TOWN OF PLAINFIELD PLAN COMMISSION REPORT

Hearing Date:	June 1, 2020	
Case No.:	PP-20-029	DP-20-026
Petitioner:	Brian J. Tuohy for ATM Hospitality, LLC	Brian J. Tuohy for ATM Hospitality, LLC
Requested Action:	Primary Plat approval for the re-subdivision of Plainfield Park, Lot 14 into Plainfield Park, Lots 14A, 14B, and 14C	A petition requesting Architectural and site design review for a proposed 4-story, 95 room Avid hotel
Parcel Size:	9.13 acres	1.92 acres
Location	2340 East Perry Rd.	2301 Hartford Ave.
Applicable Regulations:	Plainfield Zoning Ordinance Plainfield Subdivision Control Ordinance Plainfield Comprehensive Plan

PRIMARY PLAT - LOT 14
PLAINFIELD PARK - SECTION ONE

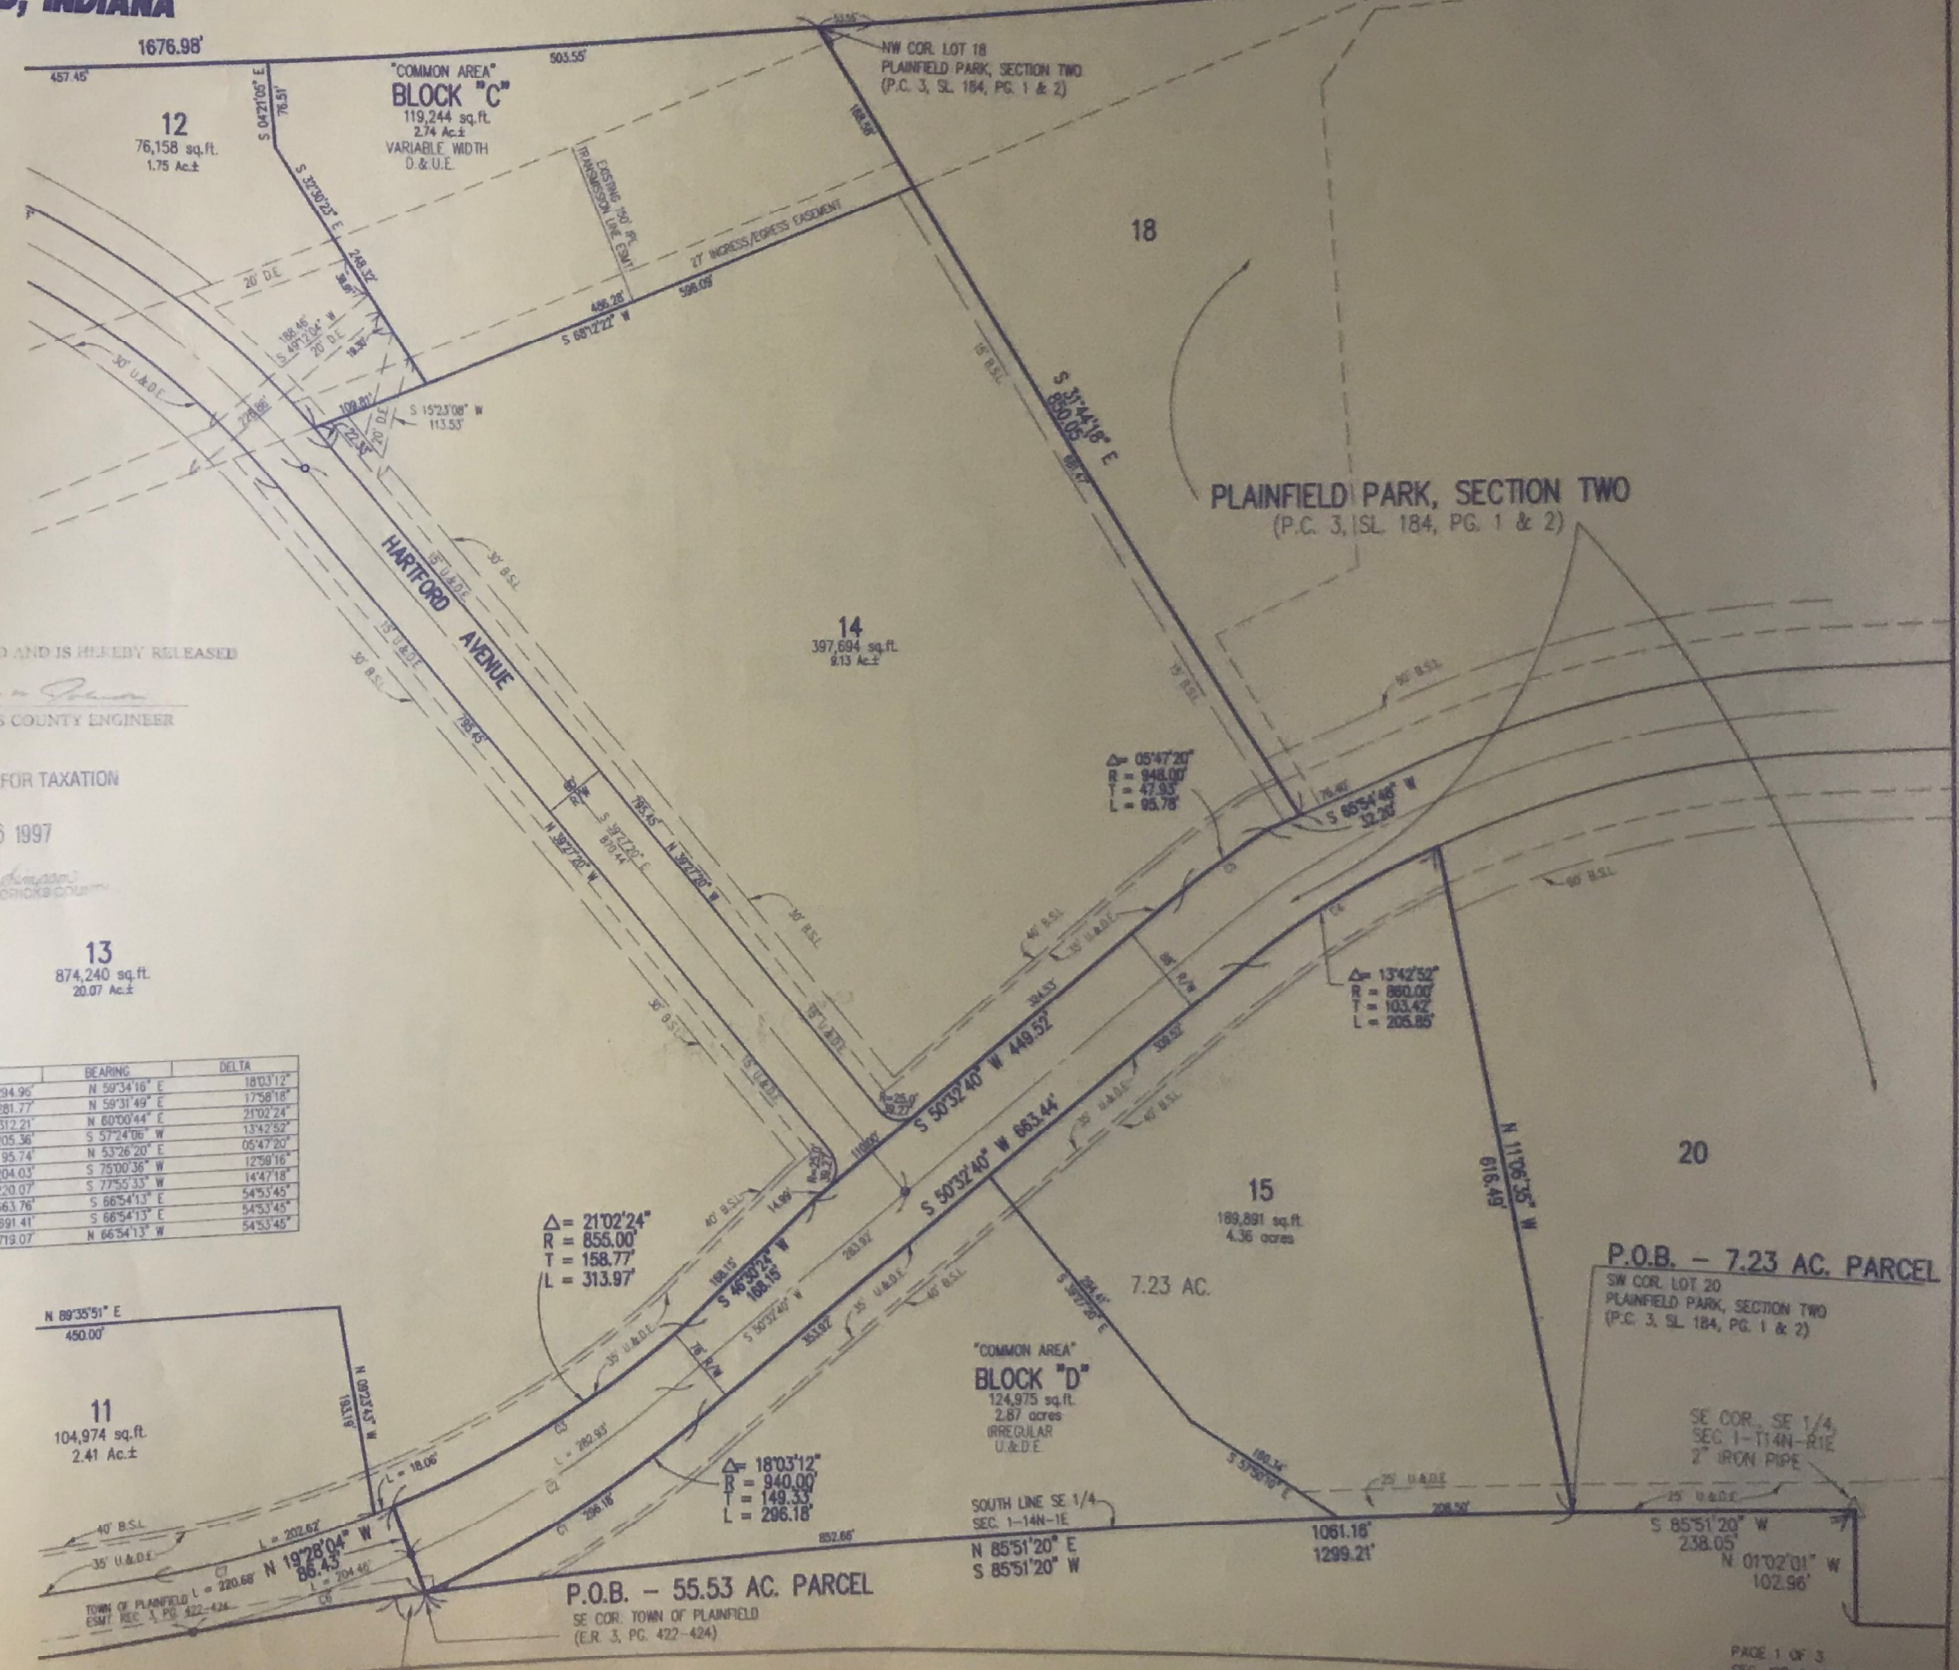
1. A cross-parcel access easement is needed across each Lot 14A, Lot 14B, and Lot 14C, either by separate instrument or on the plat, to ensure that existing and future access to public rights-of-way can potentially be used for critical access needs to each lot. The applicant has provided a copy of the Declaration of Restrictions, Covenants, and Cross-Easements for Plainfield Park which addresses this issue. A note has been added to the plat which references the document.

2. The existing “27’ Ingress/Egress Easement” across Lot 12 and Block C Common Area Plainfield Park Section 1, will need to be reclassified as “27’ Private Street” and to be constructed with maintenance guarantees being provided in accordance with the Town of Plainfield Subdivision Control Ordinance. The easement is not included in the proposed Primary Re-Plat but it will affect access to Lot 14-B in the future especially if it is further subdivided.

Similarly, and to support the recommended cross-parcel access intent, the petitioner has agreed to include a future Interior Access Drive easement across Lot 14C for the benefit of Lot 14B. The Interior Access Drive easement is proposed to be able to serve a future plan to further subdivide Lot 14B, which is illustrated as part of an ‘Overall Conceptual Development Plan’ that has been provided by the petitioner and is included for the Commission’s consideration. Creation of this easement will be handled administratively through the secondary platting process, but Staff wanted to ensure the Commission was made aware of the intended means to create access for the residual land so that it stays in compliance with the Town’s planning requirements.

***Include cross-parcel
access easement across
Lots 14A, 14B, & 14C***
